# 118 MERCER

SDCI #3036517-LU (3036455-EG)

DESIGN REVIEW BOARD RECOMMENDATIONS

# DEPARTURE REQUEST #1 - DRIVEWAY

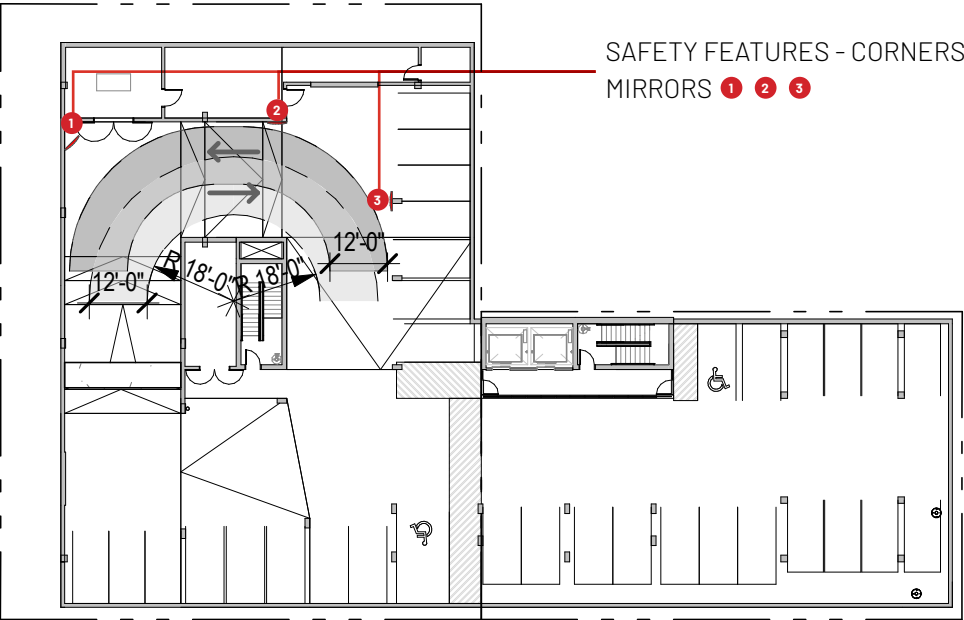
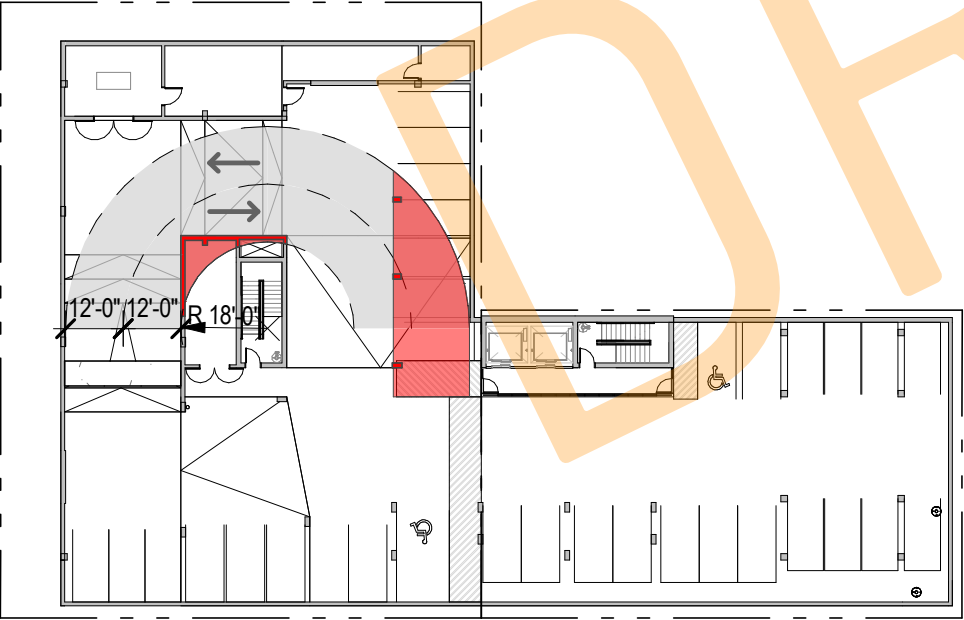
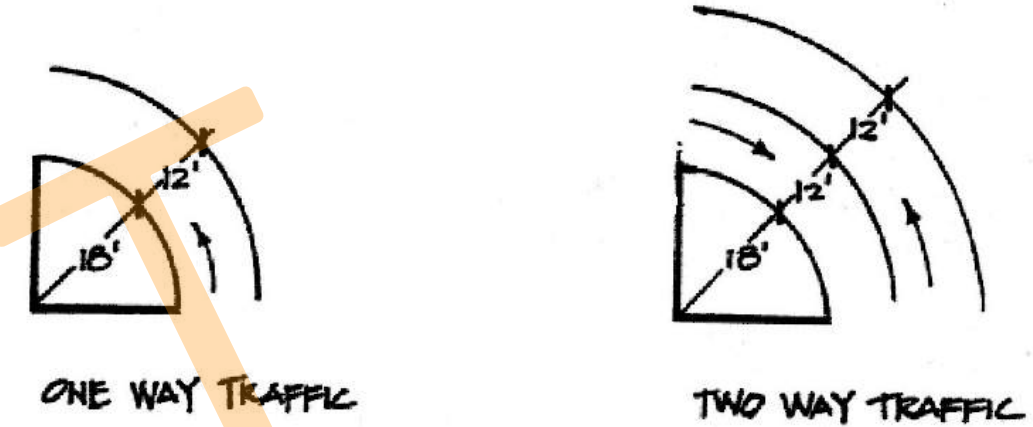
Request that the driveway is allowed to use two one-way radii with paths that overlap slightly, supplemented by safety features such as corner mirrors to provide visibility.

In order to provide garage access at the north end of the site as requested by both the neighborhood and required by SDCI staff review, the driveway placement in relation to the exterior drove the interior building design.

Requiring a two-way radius would unduly impact the function of the parking garage and would create a structural infeasible condition with the horizontal constraints of the site.

As a private, resident-only garage with secure access, two-way traffic would rarely need to be accommodated and building users will be familiar with the location of the safety mirrors and the radius conditions, creating an equivalently safe driving scenario.
